STATE OF IDAHO
DEPARTMENT OF
ENVIRONMENTAL QUALITY

MEMORANDUM

SUBJECT: Municipal Reuse Permit No. M-076-05, City of Wendell, Staff Analysis
Supporting Reuse Permit Issuance

Figure 1. MU-076-02 soil nitrate-nitrogen concentrations.

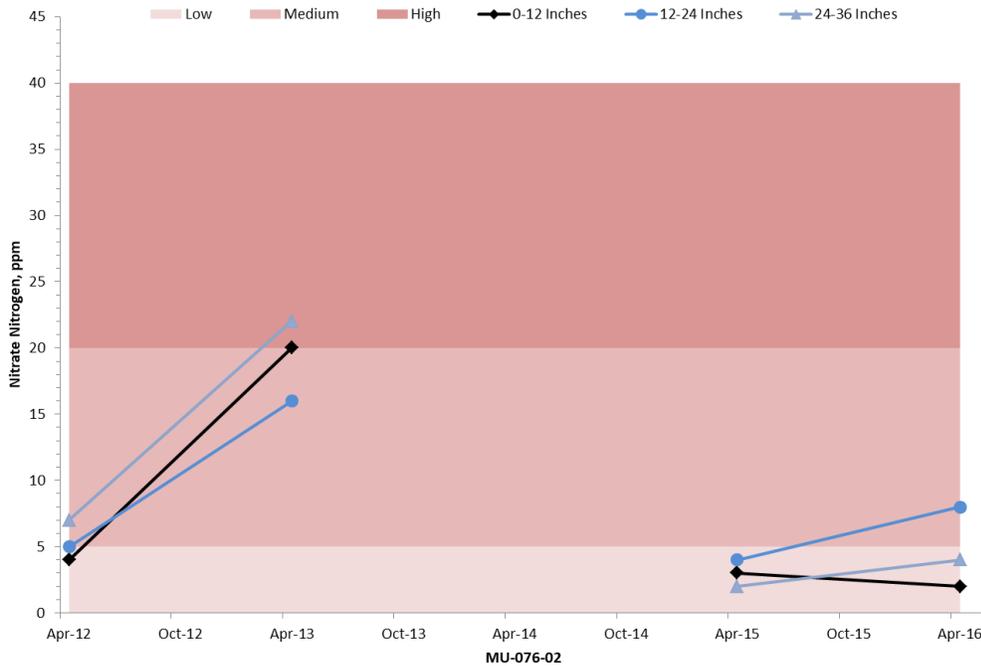
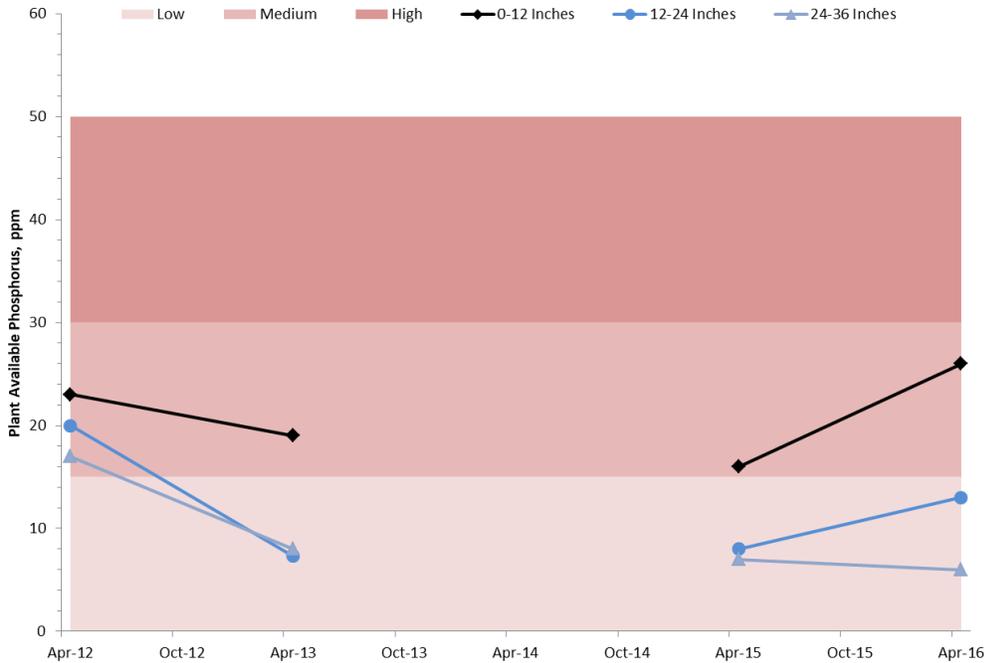
Figures 1 and 2 show the MU-076-02 soil nitrate-nitrogen and plant available phosphorus concentrations from 2012 through 2016, respectively. A soil sample was not collected from MU-076-02 in 2014. Soil nitrate-nitrogen concentrations have decreased throughout the soil profile since the permittee stopped applying recycled water to MU-076-02. The upper foot of soil continues to have slightly elevated phosphorus concentrations; however, the phosphorus concentrations in the second and third foot appear to have decreased.

Soil nitrate-nitrogen and phosphorus concentrations on MU-076-02 appear to have decreased to acceptable levels since the permittee stopped applying recycled water. It does not appear to be necessary to continue monitoring MU-076-02. DEQ recommends that MU-076-02 be considered closed and removed from the permit. Draft reuse permit M-076-05 does not specify any monitoring or reporting requirements for MU-076-02.

Figure 3. Reuse site soil nitrate-nitrogen concentrations, 0-12 inches.

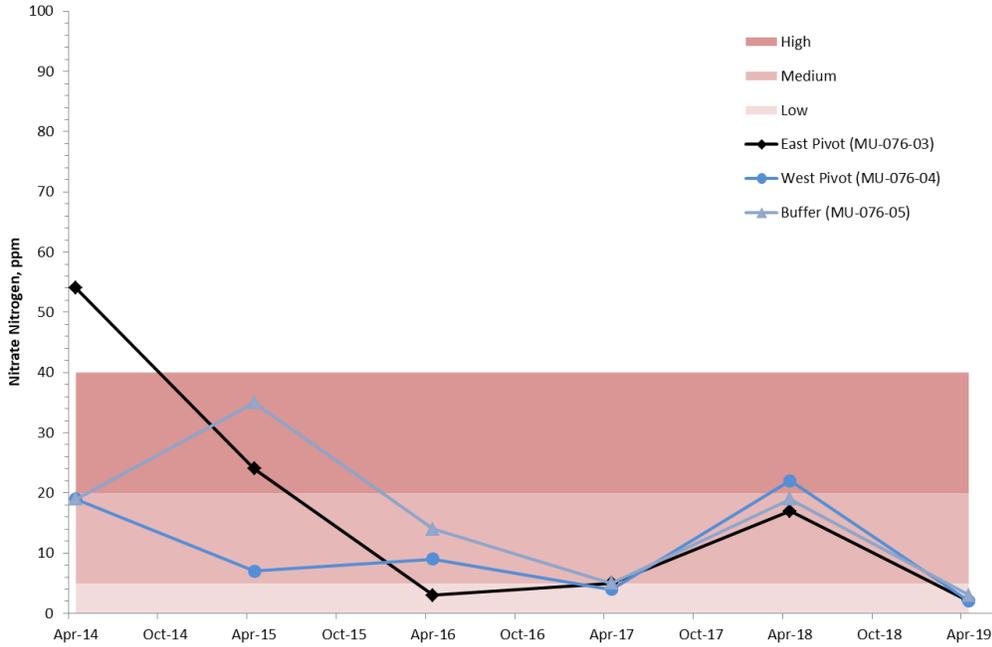
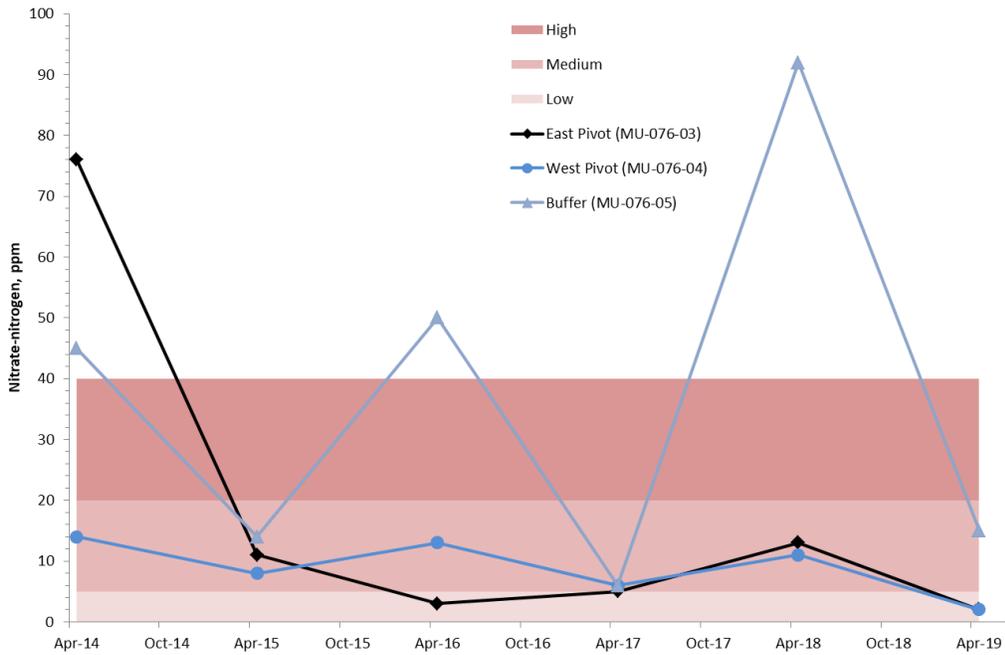
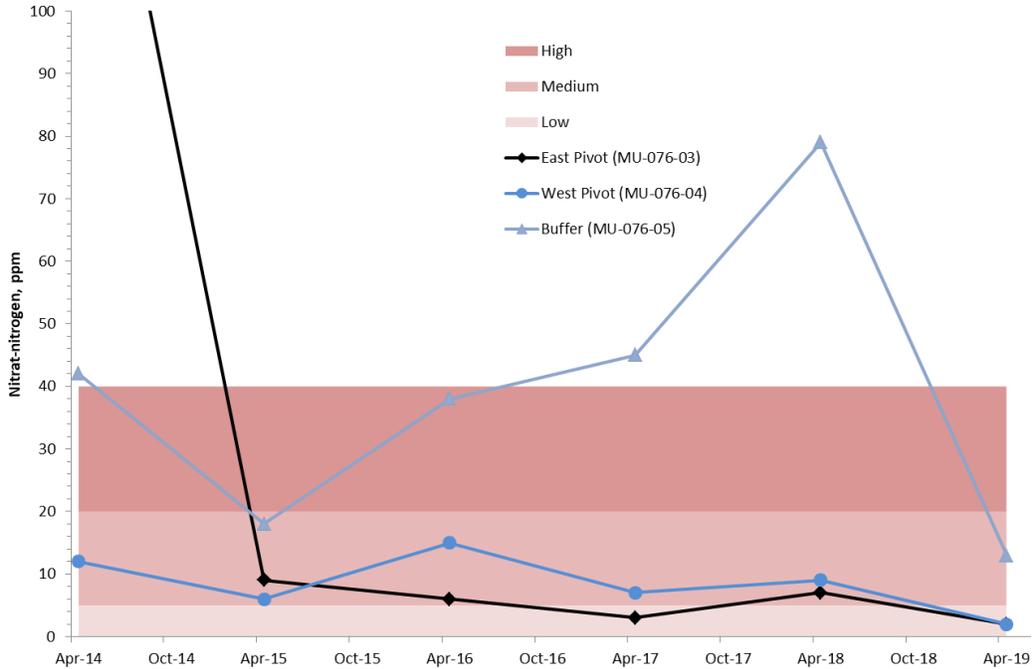
Nitrate-nitrogen concentrations in the first, second, and third foot of soil on all active management units (MU-076-03, MU-076-04, and MU-076-05) are shown in Figures 3, 4, and 5, respectively. Nitrate-nitrogen concentrations on MU-076-03 were initially high throughout the soil profile but appear to have decreased since the permittee began operating it under the reuse permit. The cause of the initial elevated nitrate-nitrogen concentrations is likely over fertilization by the previous owner. There was a spike in nitrate-nitrogen soil concentrations on all management units in 2018. This is likely the result of the excessive amount of nitrogen fertilizer applied to the entire site in 2018 at a rate of over 900 pounds per acre (lb/acre; JUB 2018b). The permittee must ensure that nitrogen is applied to the site at agronomic rates. Excessive nitrate-nitrogen in the soil could potentially leach to ground water.

Figure 6. Reuse site soil phosphorus concentrations, 0-12 inches.

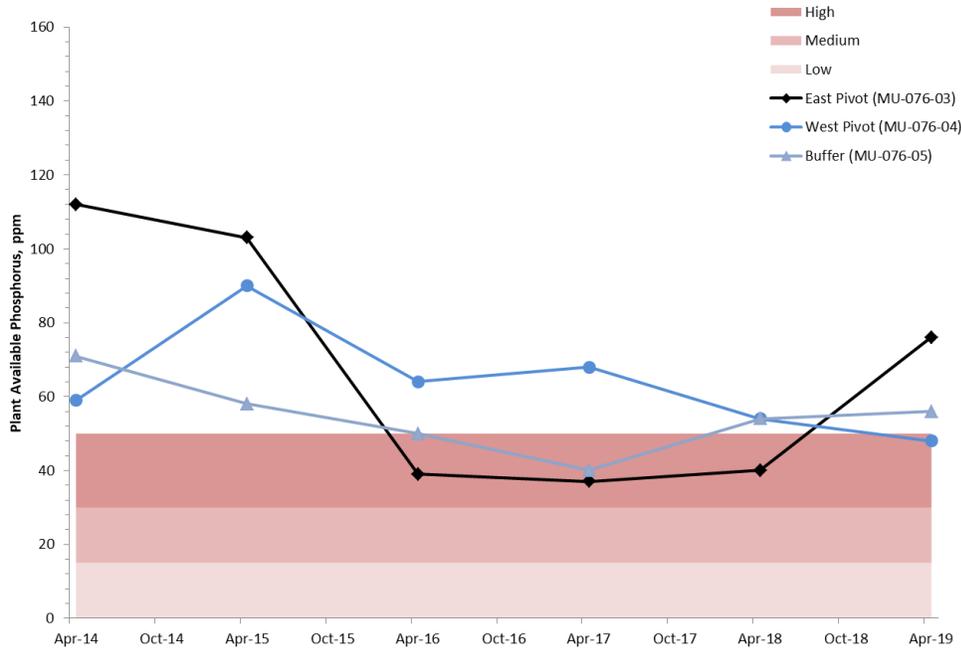
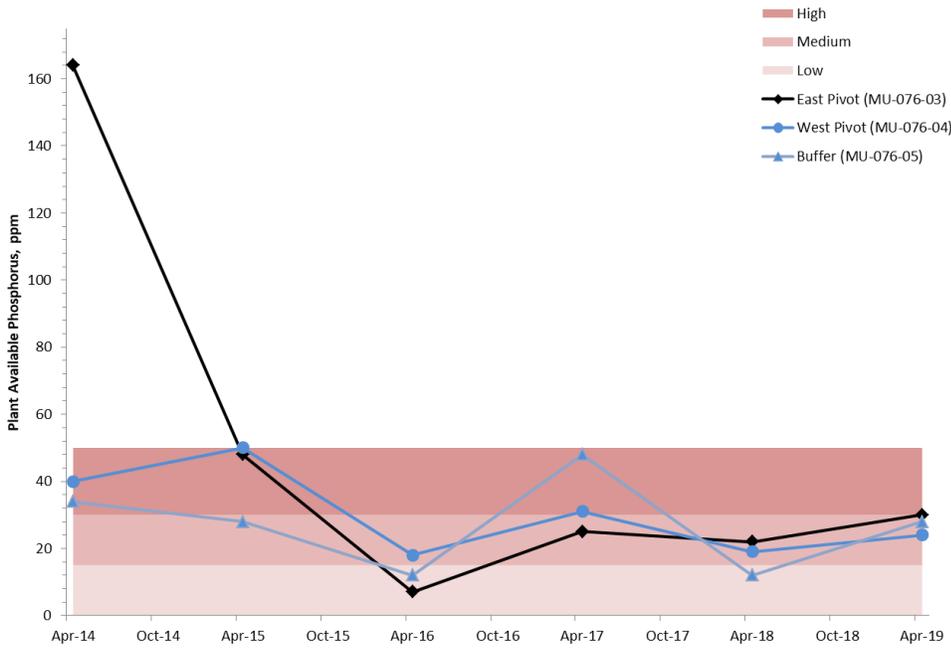
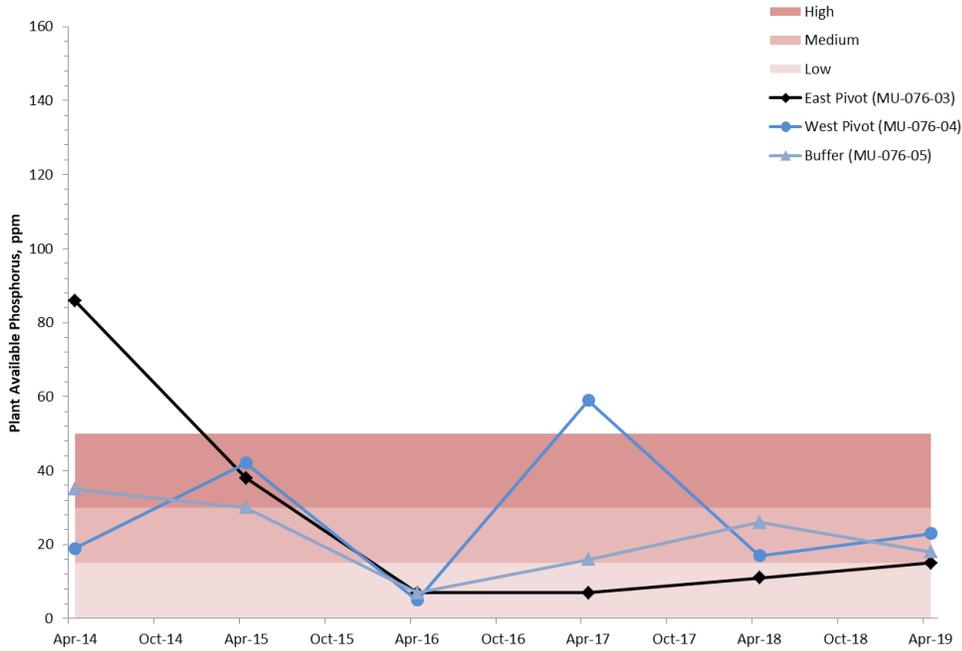
Plant available phosphorus concentrations in the first, second, and third foot of soil on active management units (MU-076-03, MU-076-04, and MU-076-05) are shown in Figures 6, 7, and 8, respectively. Phosphorus concentrations were initially excessive on all three management units. Again, this was likely the result of over fertilization by the previous owner. Phosphorus concentrations appeared to be decreasing; however, phosphorus concentrations increased in 2018 and 2019. Similar to the soil nitrate-nitrogen concentration spike, the phosphorus increase is likely the result of excessive phosphorus fertilizer application rates in 2018 at over 500 lb/acre.

Phosphorus applied to the soil surface can be stored in the soil profile by precipitation and adsorption to soil particles. Eventually, with significant phosphorus loading, phosphorus can migrate to lower soil levels and even below the root zone. Once it goes beyond the root zone, the phosphorus is unavailable for crop uptake. There is the risk that phosphorus may breakthrough to ground water, which in turn can transport phosphorus from the site to other areas (DEQ 2007b, Section 4.2.2.7, p. 4-31). Runoff or leaching from reuse site soils could potentially contaminate nearby surface waters such as the canal bordering MU-076-05 to the west.

The permittee must ensure that phosphorus is applied to the site at agronomic rates. The permittee should use soil nutrient concentrations to determine the crop nutrient requirements each growing season. Fertilizer applications should be coordinated between the permittee and the contract farmer to ensure loading rates are not excessive. Section 4.6.3 discusses reuse site constituent loading rates.

Figure A-7. City of Wendell reuse permit facility map.

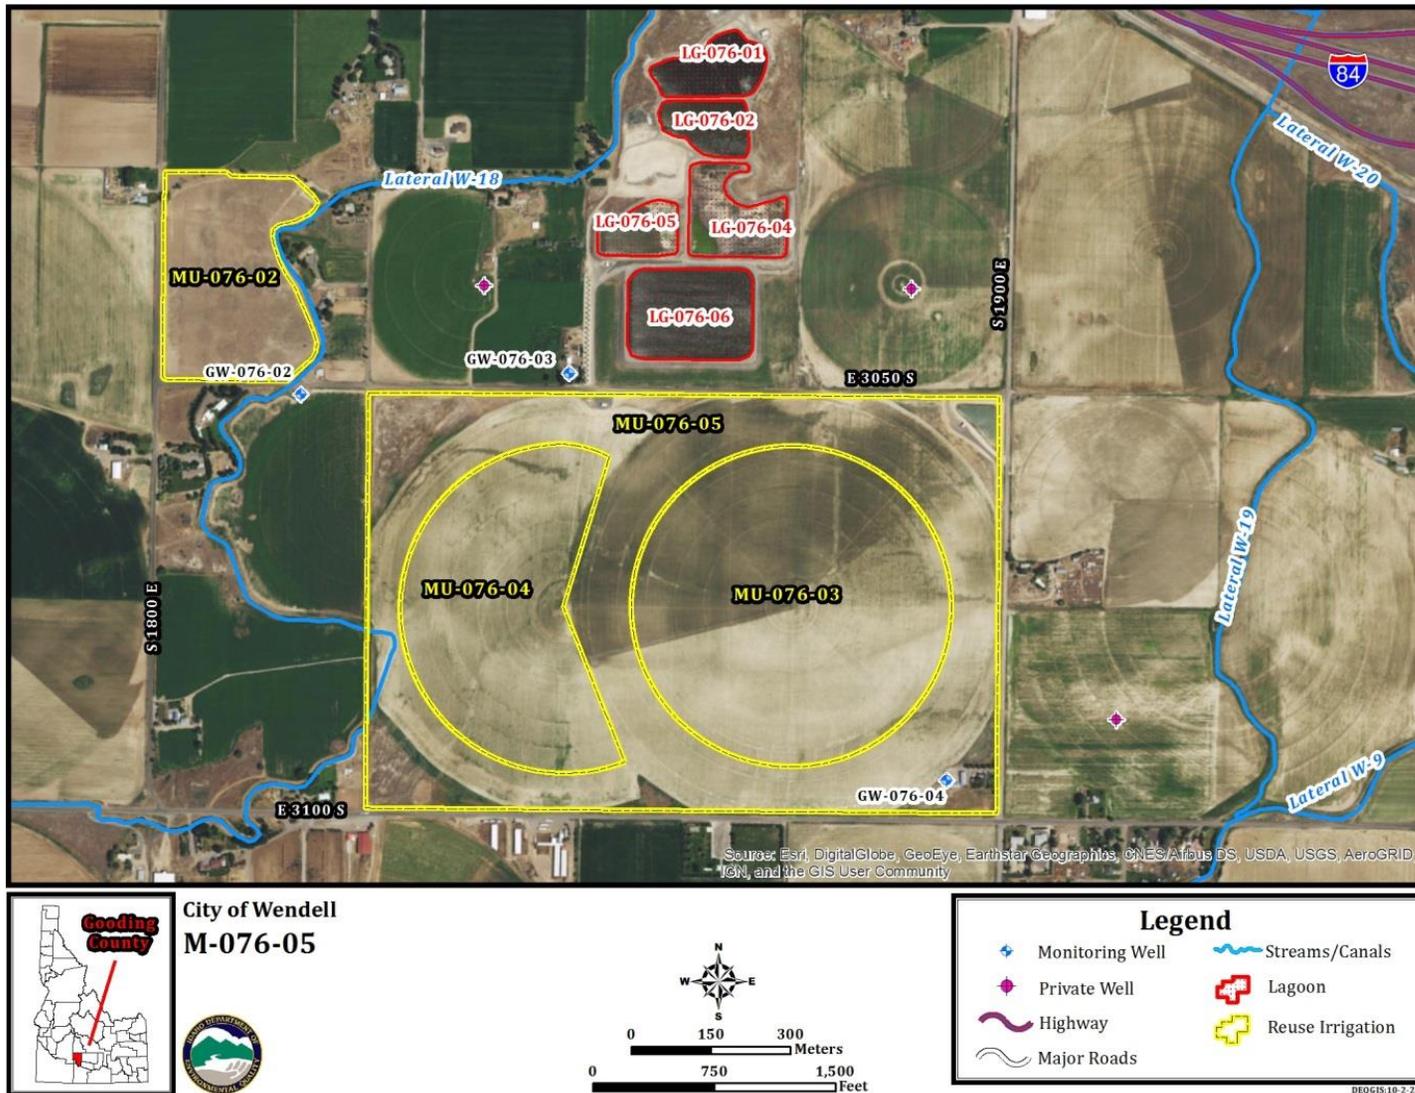
- MU-076-05 is comprised of the remaining 131.6 acres of the reuse site that is not irrigated by the recycled water irrigation system (JUB 2017c, Table 3-1, p. 9). The current permit (M-0076-04) allowed recycled water to be applied to this management unit provided the permittee complied with the required buffer zone distances (DEQ 2012d, Section 4.1, p.8). The permittee currently uses SIW to irrigate 99.6 acres of MU-076-05 (JUB 2020a). The recycled water irrigation system is not currently designed to apply recycled water to any portion of MU-076-05. The current permit inaccurately states that MU-076-05 is irrigated by wheel lines.

The current management unit descriptions included in reuse permit M-0076-04 do not accurately represent how the reuse site is being managed. Recycled water is only applied to management units MU-076-03 and MU-076-04. Recycled water application to MU-076-05 should not be allowed in order to maintain the required buffer zone distances. If the permittee ever desires to expand the permitted area of management units MU-076-03 or MU-076-04, an updated buffer zone management plan and plans and specifications for the modification of the recycled water irrigation system shall be submitted to DEQ for review and approval.
